Case Reference: HGY/2024/0914

One Pound Lane, N6 5TT

OBJECTION from Chris Hallatt Wells & Lucille De Silva, 13 Stanhope Gardens, N6 5TT

**Objection to retrospective
planning application
HGY/2024/0914**

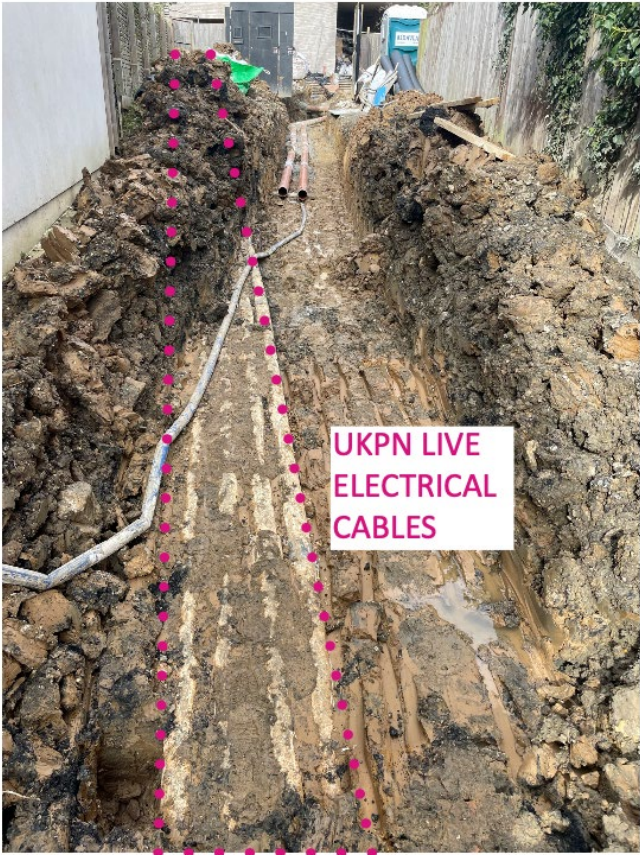
Comment 1.	As the photograph below confirms, the UKPN cables are not near the surface of the garage forecourt. This photograph was taken after the UKPN cables had been buried. Layers of black asphalt and yellow asphalt were later laid on top of the aggregate layer shown in the photograph. Installing an ACO drain would only require cutting into the asphalt along the left / north of the concrete foundation strip. There is no risk of coming into contact with the UKPN cables. Installing an ACO drain on right / south side of the foundation strip would pose no risk whatsoever to the cables. If the cables are located in this area, they are more than 1m below the level of the asphalt and soakaway.

Comment 2.	The Additional Information states that: <i>“Digging in that area is not possible”</i> due to the presence of UKPN live electricity cables. This is not true. During the building works the UKPN cables were excavated on more that one occasion using a small digger. If digging was carried out to a depth exposing the cables, why is this not possible now?
------------	--

Location: garage at rear of 11 Stanhope Gardens & garage forecourt 1 Pound Lane

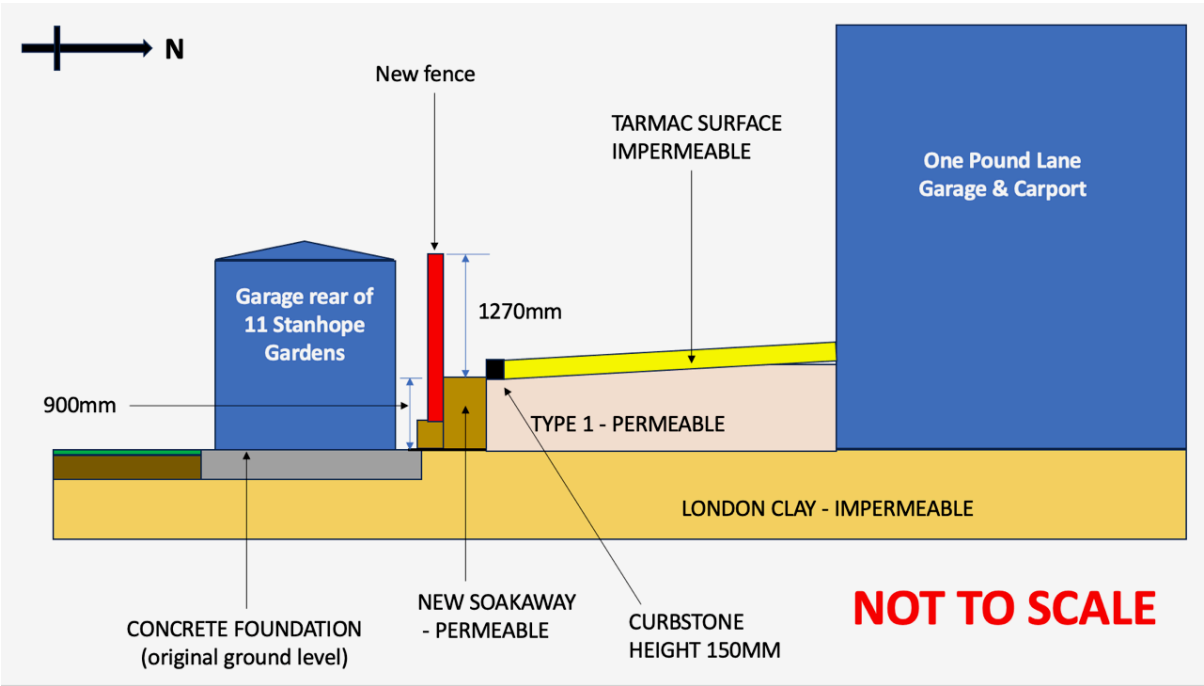
ISSUE	DESCRIPTION	EVIDENCE
Increase in ground level beyond 700mm	The Application seeks consent to increase ground levels by up to 700mm. The ground level at this point has been raised by 1015mm	• Drawing • Photograph • Site visit

The spirit level indicates the raised ground level on the otherside of the new fence.

The soil below the fence is part of the new soakaway strip installed by the developer.

The concrete visible below the soil is the original ground level. The concrete is the foundation of the no. 11's garage.

The increase in the ground level is measured from the concrete to the spirit level plus the height of the curbstone shown in the drawing.

This increase is approximately 105mm

NOTE: there is no retaining structure below the fence to support the side of the soakaway or to prevent water draining freely into the garden of no. 11.

Location: north east corner of side extension of 13 Stanhope Gardens

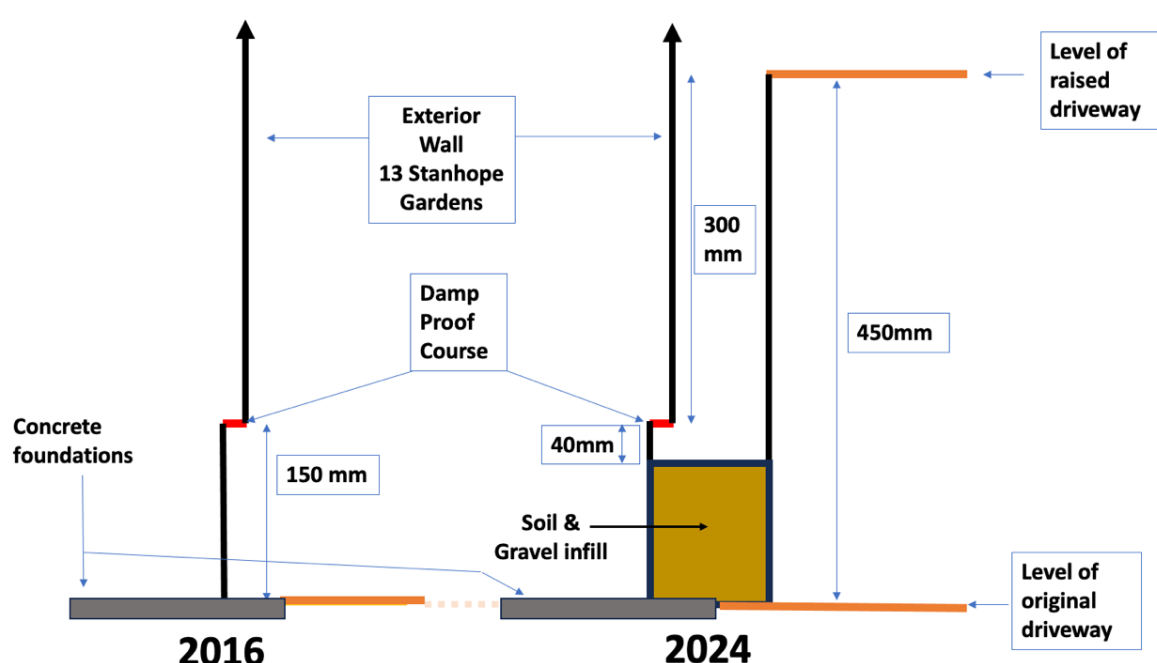
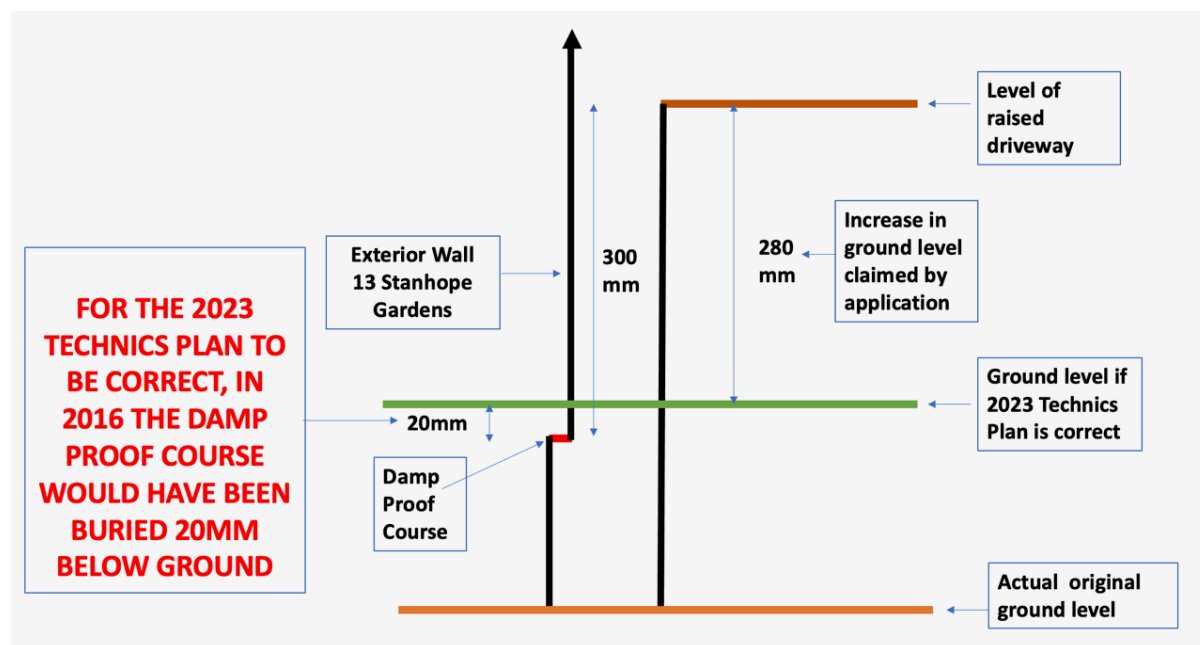
ISSUE	DESCRIPTION	EVIDENCE
Increase in ground level above the damp proof course ("DPC") of 13 Stanhope Gardens	Prior to the building of One Pound Lane the DPC of the side extension of 13 Stanhope Gardens was at least 150mm above the adjacent ground and the original driveway. The ground level of the driveway is now 300mm above the level of the DPC. This indicates that the ground level has been raised at least 450mm (i.e. 150mm + 300mm). The 2023 Technics Plan incorrectly shows that the ground has only been increased by 280mm	• Drawings below • Photograph • Independent GPS site survey comparing ground levels in 2016 & 2024 • Site visit

Drawing showing the change in ground levels between 2016 and 2024. This can be confirmed by a site inspection

The 2023 Technics Plan shows incorrectly that the ground level has only been increased by 280mm. If the 2023 Technics Plan was correct the DPC of 13 Stanhope Gardens would have been 20mm below ground in 2016 (see drawing below).

The evidence shows that the clearance between the DPC and adjacent ground from 2016 (until the ground level was raised) was at least 150mm as required by Building Regulations. The 2023 Technics plan must therefore be incorrect.

Image 1

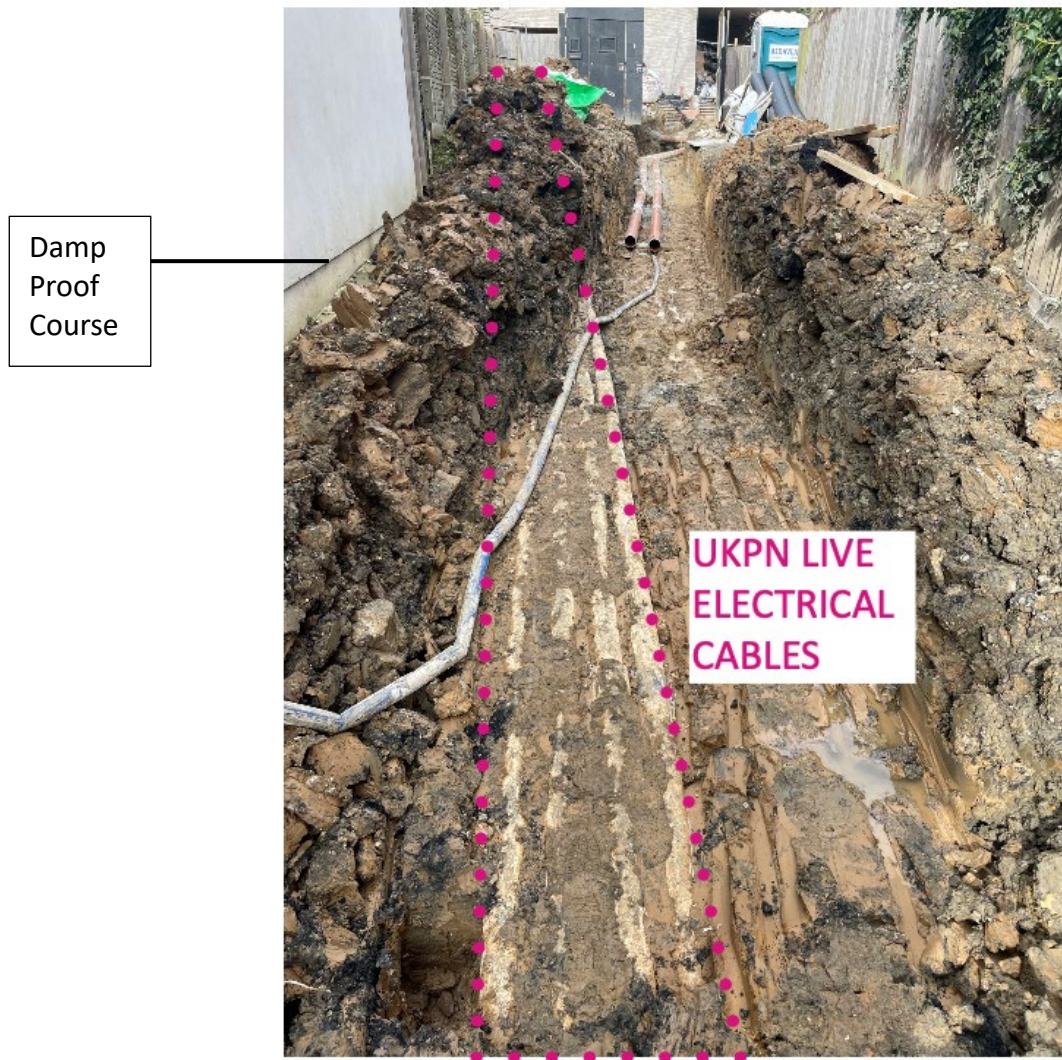
Image 1 shows that the damp proof course of 13 Stanhope Gardens (on the left side of the picture) was above the level of the adjacent ground even whilst the excavation of the driveway to install services was underway. Note that Image 1 was submitted by the developer in its application.

Image 1 was taken before May 2023

E. Independent GPS site survey showing the change in the profile of the driveway between 2015 and 2024

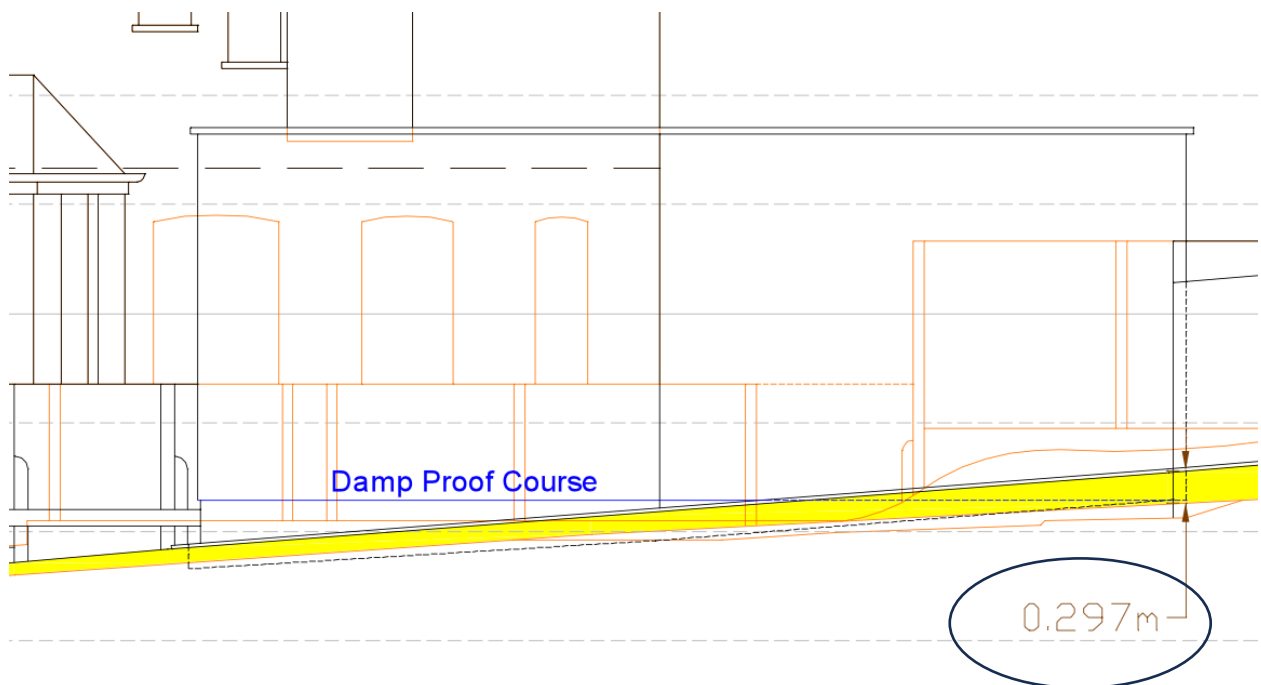
Extract from the 2024 survey highlighting the change in the level of the driveway relative to the height of the damp proof course of 13 Stanhope Gardens.

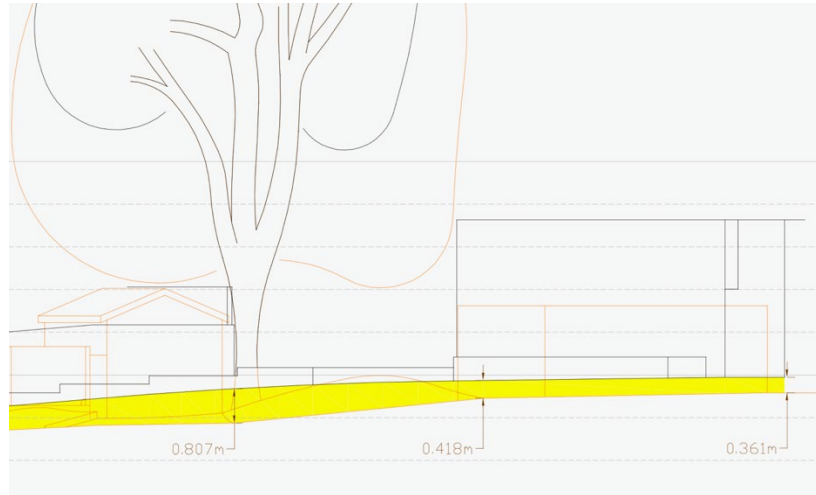
- The soakaway is less than 1 meter from the garage at the rear of 11 Stanhope Gardens. A garage falls within the legal definition of a building for the purposes of Building Control.

- The soakaway will not prevent water runoff onto neighbouring properties because the soakaway is above the adjacent ground (see photograph below) As the application notes, the soil type is impermeable clay. Water entering the soakaway will percolate through the soakaway until it reaches the impermeable clay. It will then drain freely into the gardens of 9 and 11 Stanhope Gardens.

Raised ground level of Pound Lane garage forecourt on the other side of the fence

Height of soakaway above original ground level

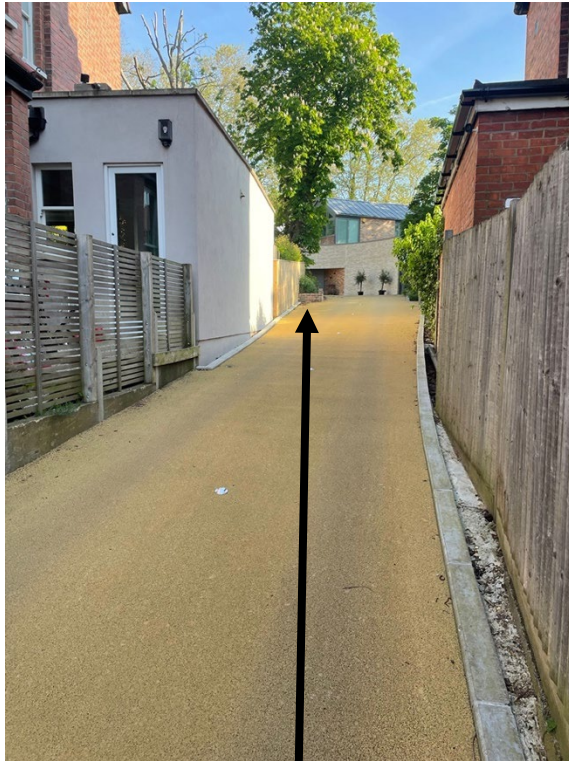
Weep holes are
not visible

Soakaway

The base of the soakaway is above the level of the grassed lawn of 13 Stanhope

Raised flower bed

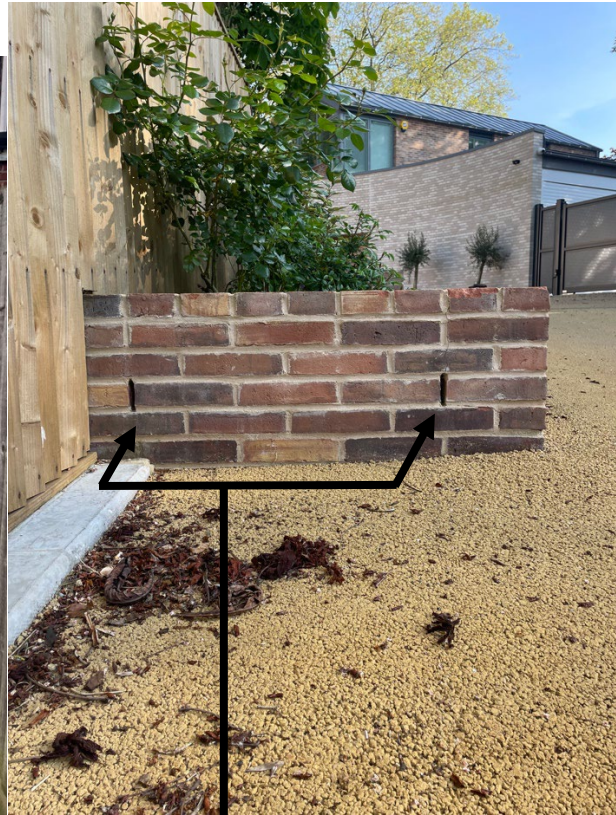
Weep holes:

Cosmetic not functional.
